1207 PLOT 9B FIRST STREET, MANCHESTER

NMA APPLICATION REPORT

1207-TGA-XX-XX-RP-A-FI_10_10-00400 P01

TIM GROOM ARCHITECTS

Approved Planning Drawing - VS9B-TGA-G251-DE-XX-95219

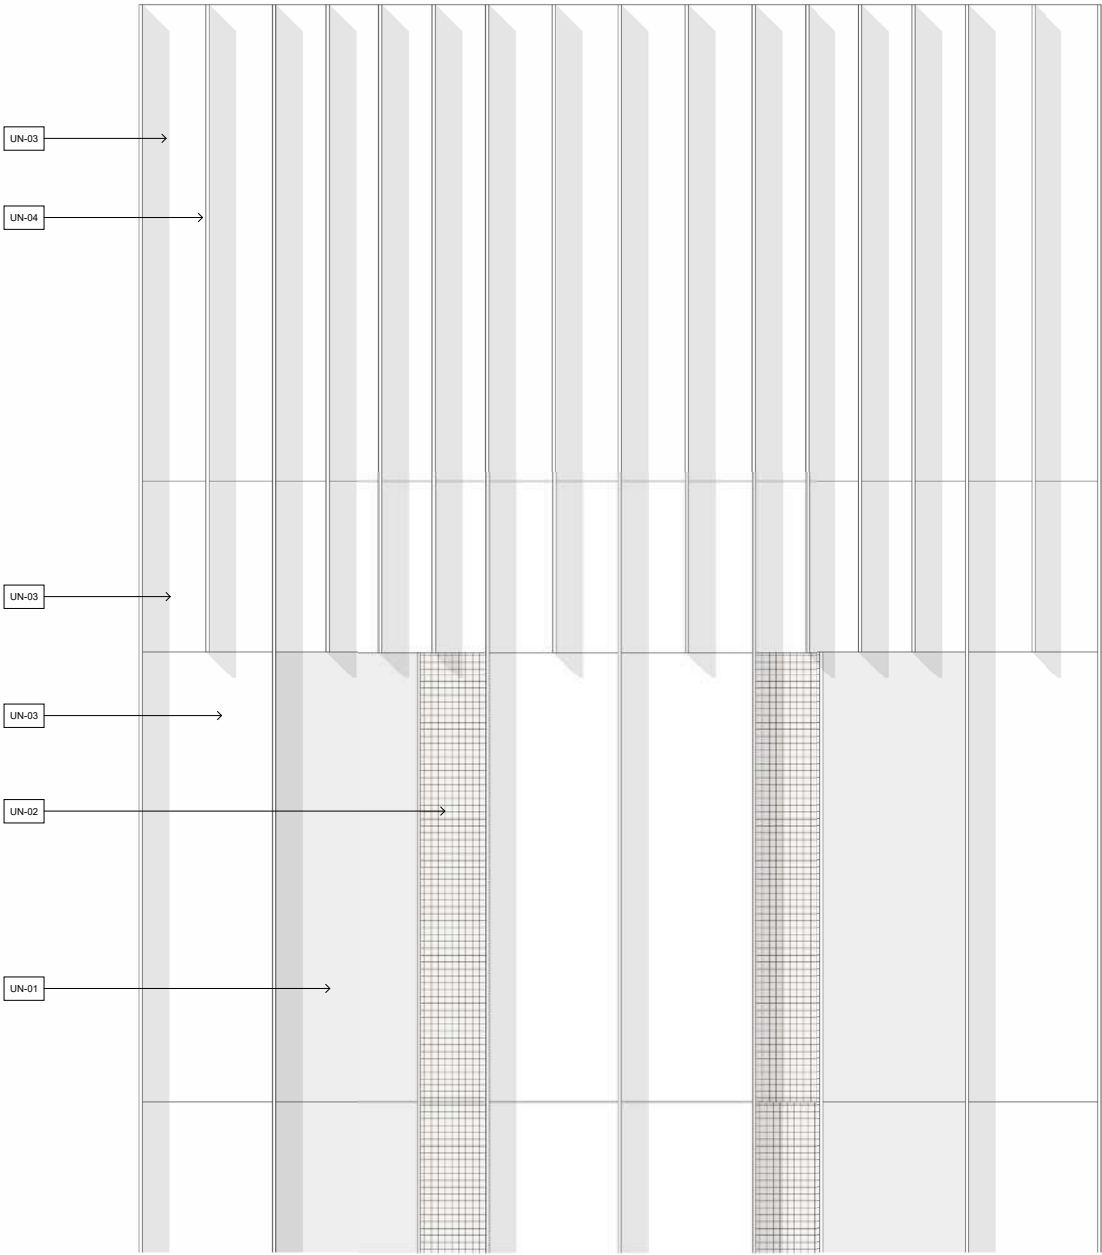
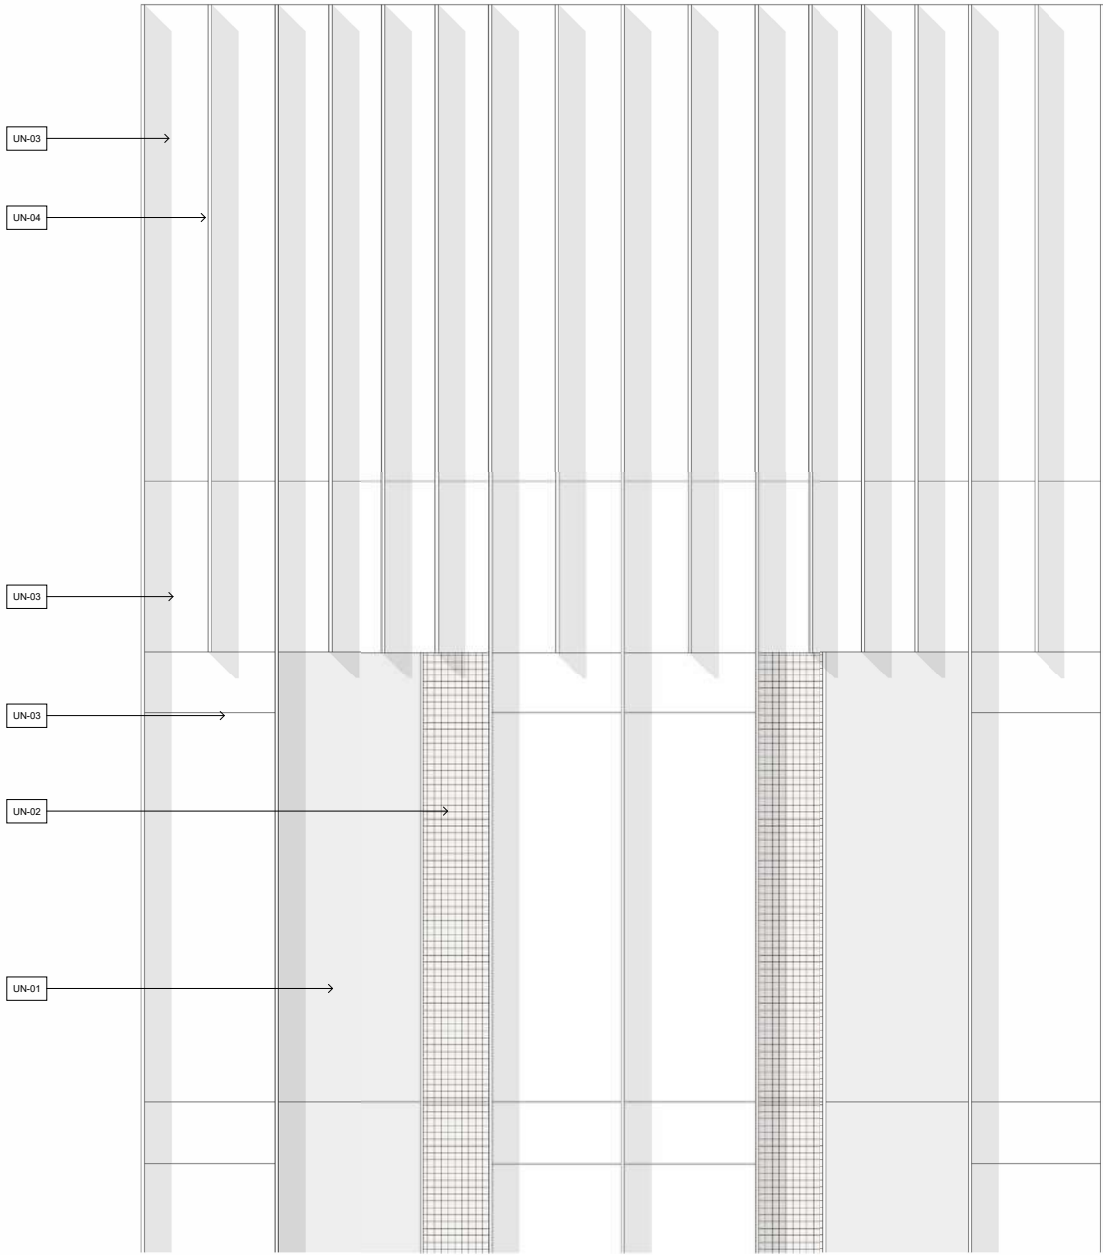
Proposed Revised Drawing

External Door Widths

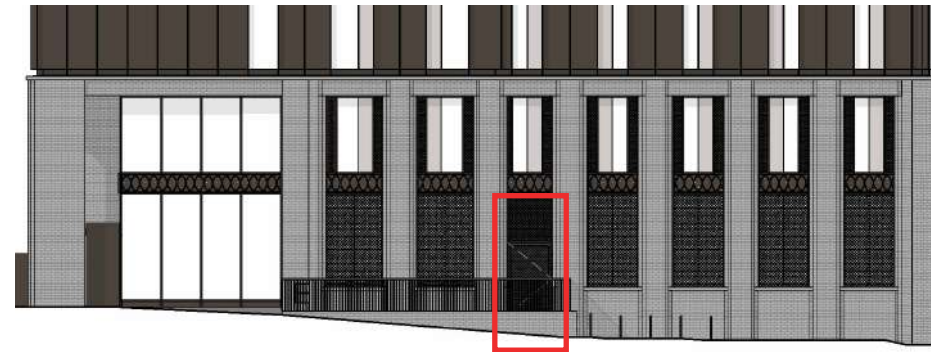
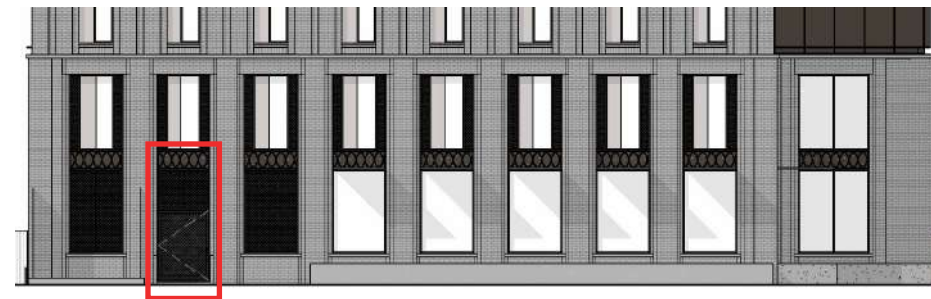
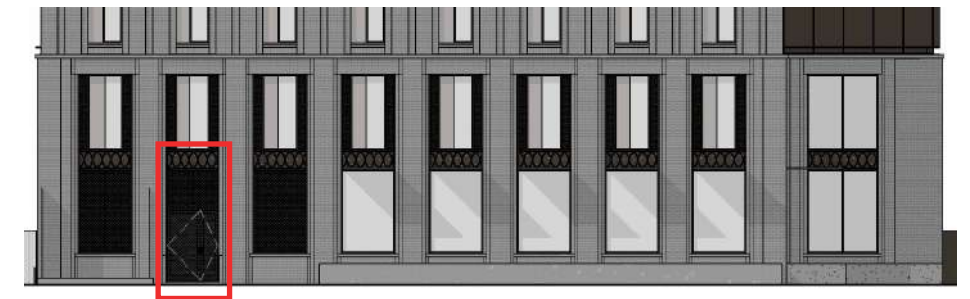
Following procurement of specialist sub-contractor design, the design team have been advised that, three of the ground floor external door widths on the approved drawings are not feasible as one large door leaf.

As such, these doors are required to be split into two asymmetrical leaves.

The revised solution maintains the minimum required opening dimensions while allowing for ease of opening by the operative.

The following doors are to be revised -

- Refuse Store Door (*West Elevation*)
- Escape Door (*North Elevation*)
- Escape Door (*East Elevation*)
- Cycle Store Door (*North Elevation*)

Additional Minor Amendments
Back of House External Ramp

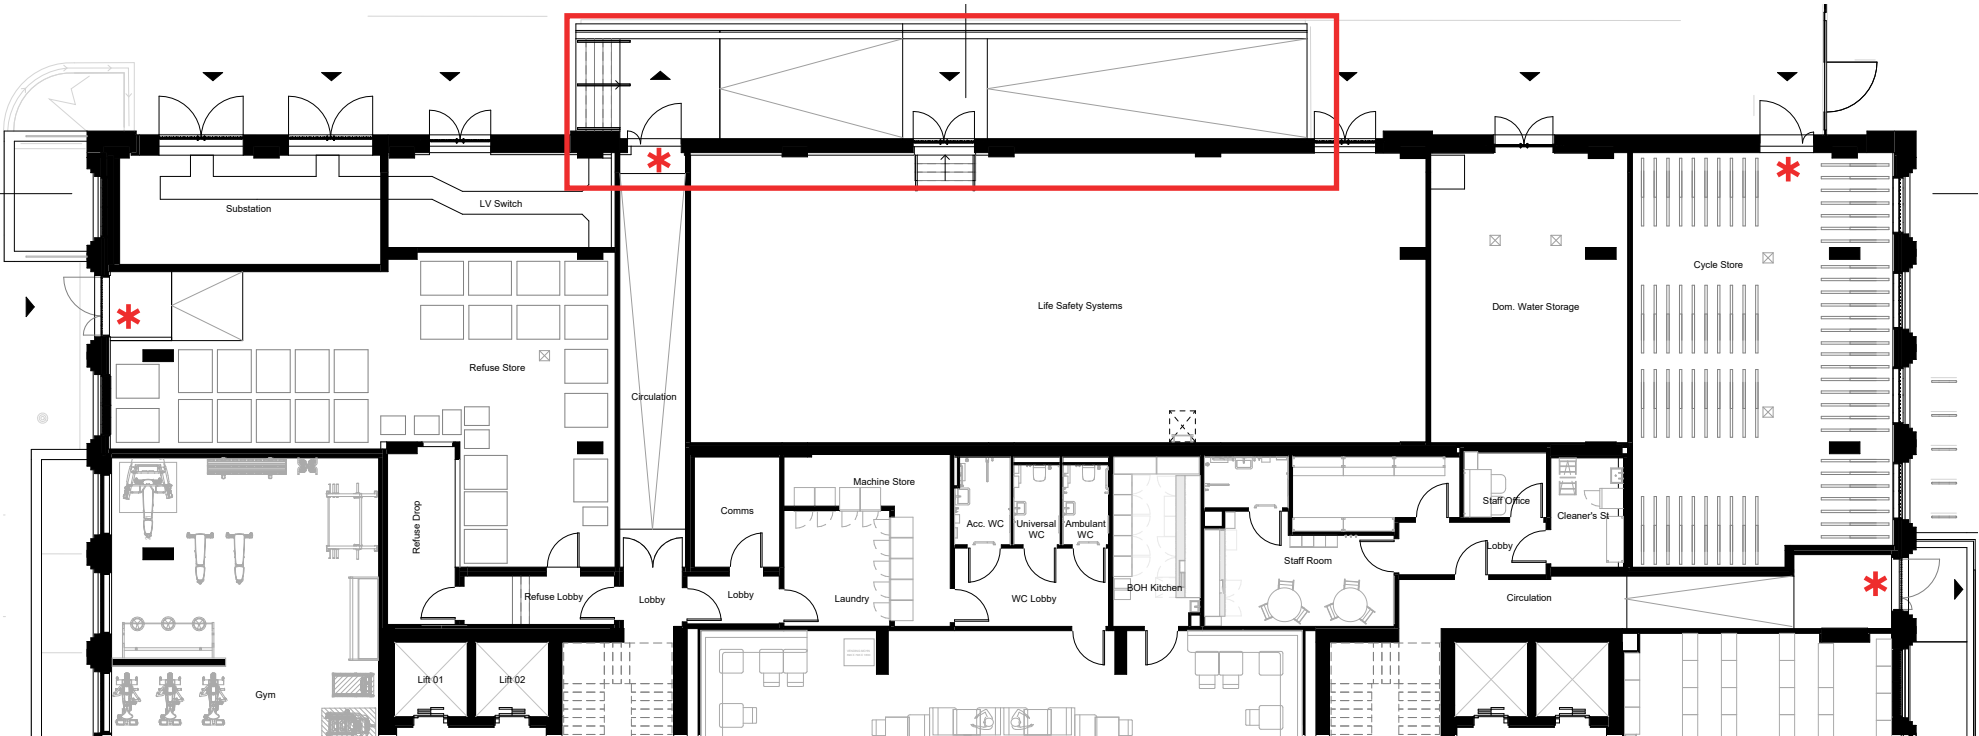
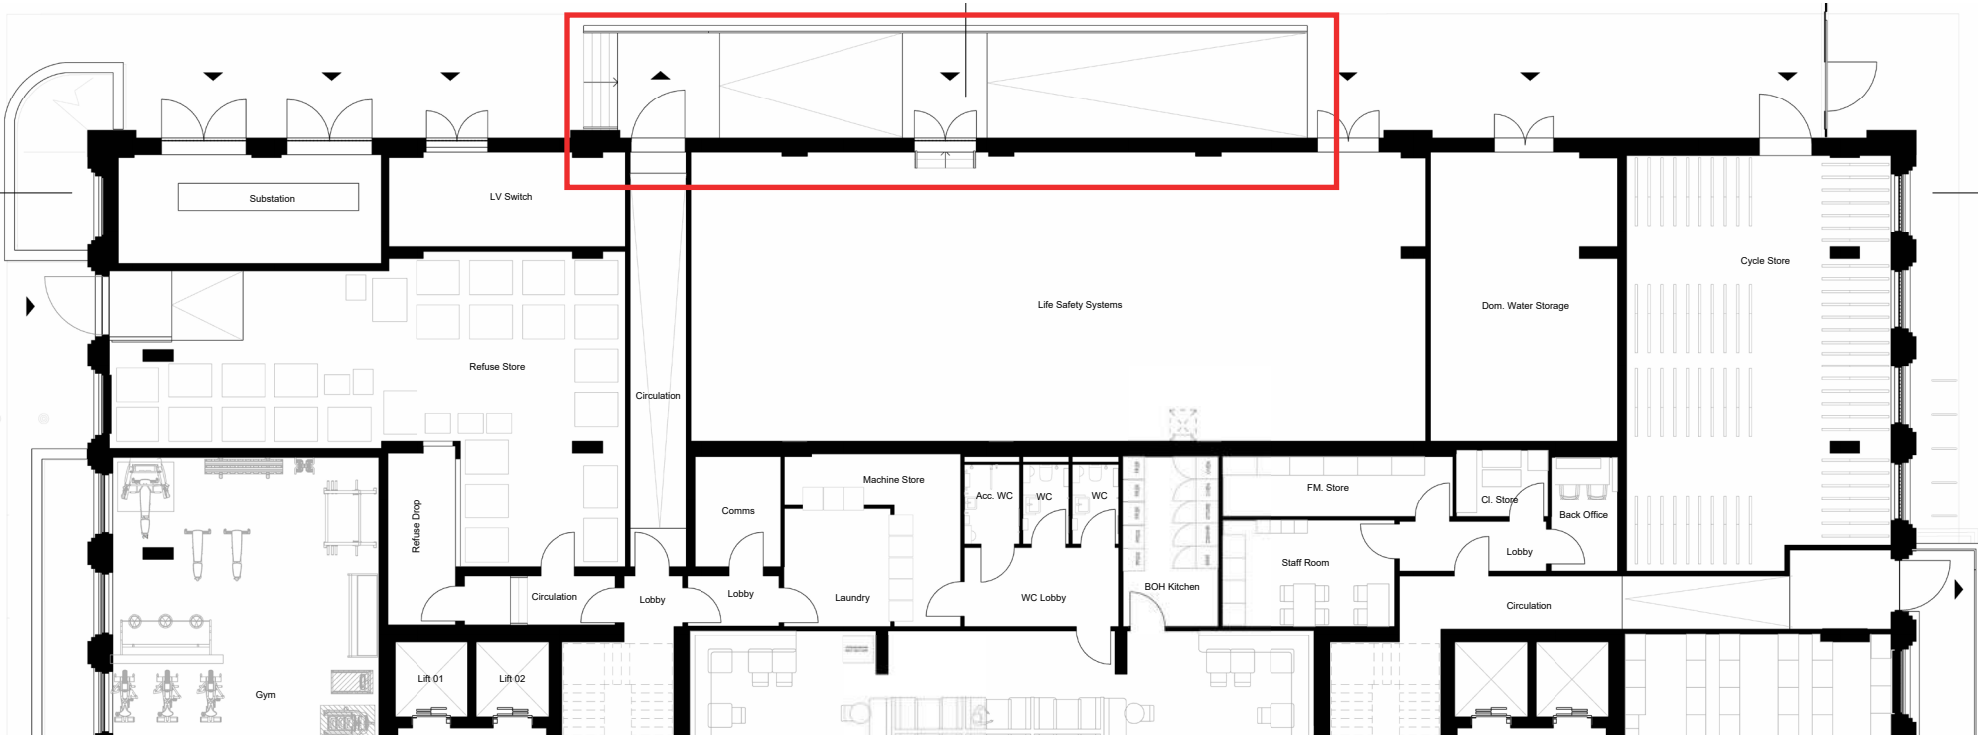
The BOH Ramp has been reduced in width to ensure the balustrade design meets the minimum line load requirement.

The reduction is nominal and maintains the minimum distances required for access and egress.

**Note the revised external door swings are also picked up on the revised Ground Floor drawing.*
